Access Compliance Report Public Rights-of-Way (Curb Ramps)

Main Street: ANTONIO_PKWY Cross Street: SENDERO_WAY Location: SW

ADA ID: RPRK211116133438 Ramp Type: Type 1 - Perpendicular Diagonal Initial Pass/Fail: Pass Overall Compliance: No Severity Score: 0

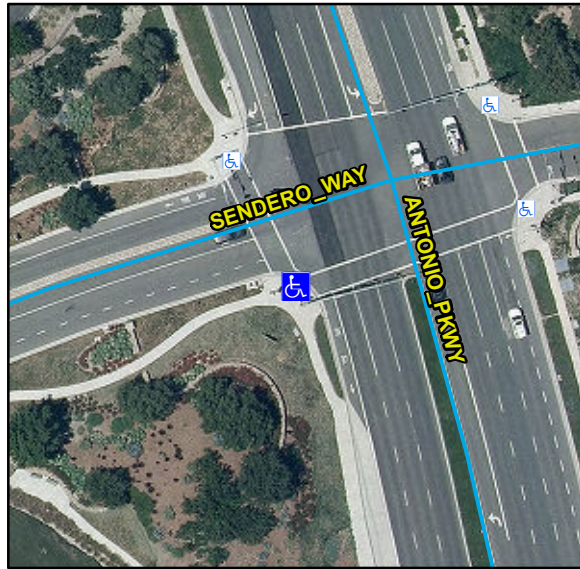
Surveyor Notes:

N/A

Possible Solutions:

Remove & Replace Landing.

OC Std/PROW:

R304.5.3, STD 1115
